NL-11-1960

Joseph M. Farley Nuclear Plant
License Amendment Request to Adopt TSTF-513-A Revision 3
Response to Request for Additional Information
Regarding Requiring Performance of Reactor Coolant System Mass Balance

**Response to Request for Additional Information Regarding
Requiring Performance of Reactor Coolant System Mass Balance**

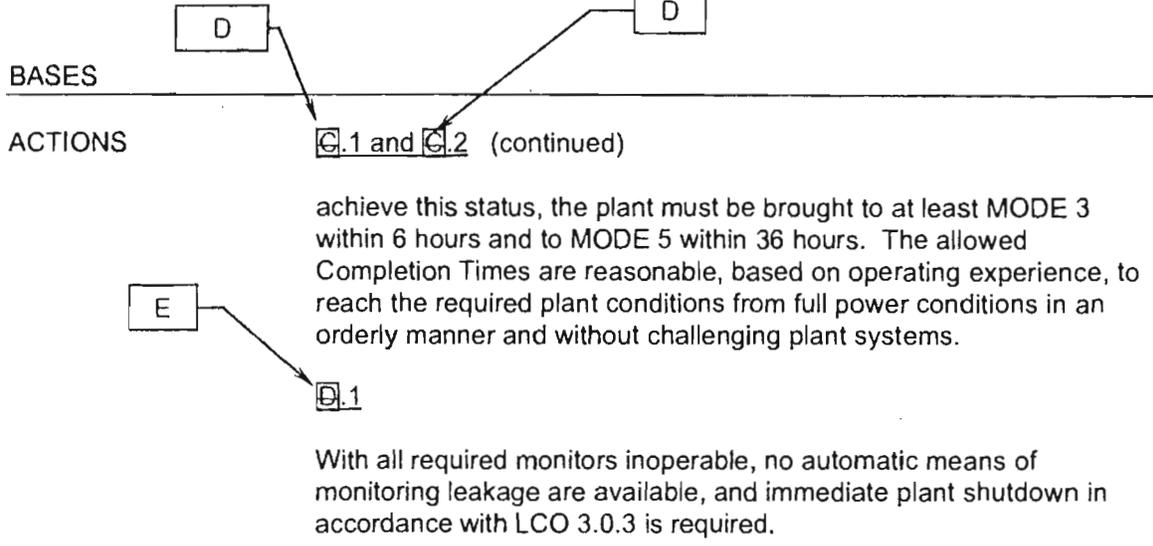
Insert 3

D

D

The 24 hour interval provides periodic information that is adequate to detect leakage. The 30 day Completion Time recognizes at least one other form of leakage detection is available.

C.1 and C.2

, B, or C

If a Required Action of Condition A ~~or B~~ cannot be met, the plant must be brought to a MODE in which the requirement does not apply. To
